**SAN ANTONIO WATER SYSTEM
DOS RIOS WRC FIRST STAGE DIFFUSER REPLACEMENT
SAWS Job No. 13-6502
SAWS Solicitation No. B-13-075-MF**

**ADDENDUM No. 1
November 11, 2013**

**FIRST STAGE AERATION
BASIN DIFFUSER
LAYOUT (TYP)**

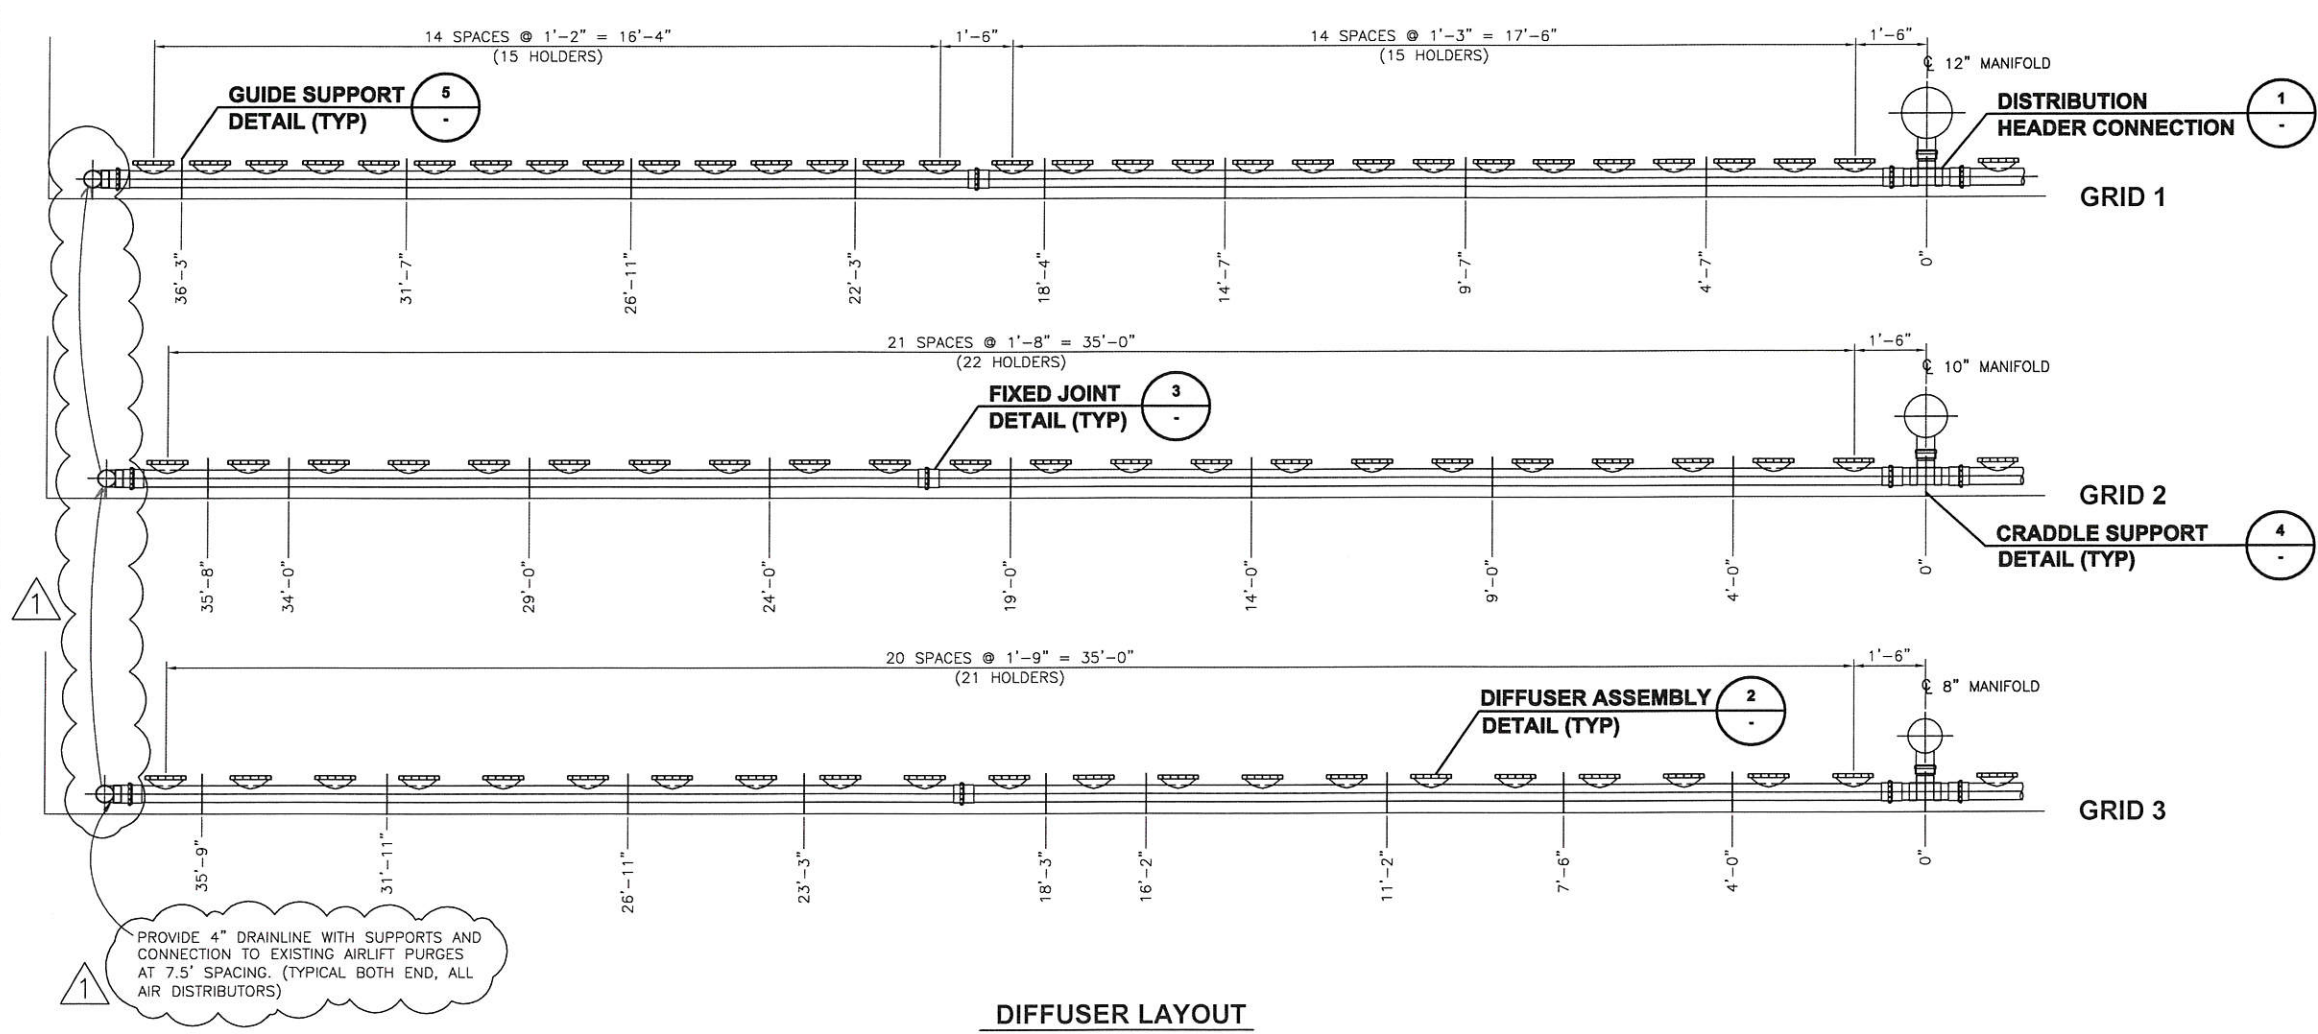
7. Sheet M2, REMOVE and REPLACE Note referring to drainline. This note is applicable to all Grids (Grid 1, 2, and 3).

“Provide 4” drainline with supports and connection to exiting airlift purges at 7.5’ spacing. (Typical Both Ends, all air distributors)”
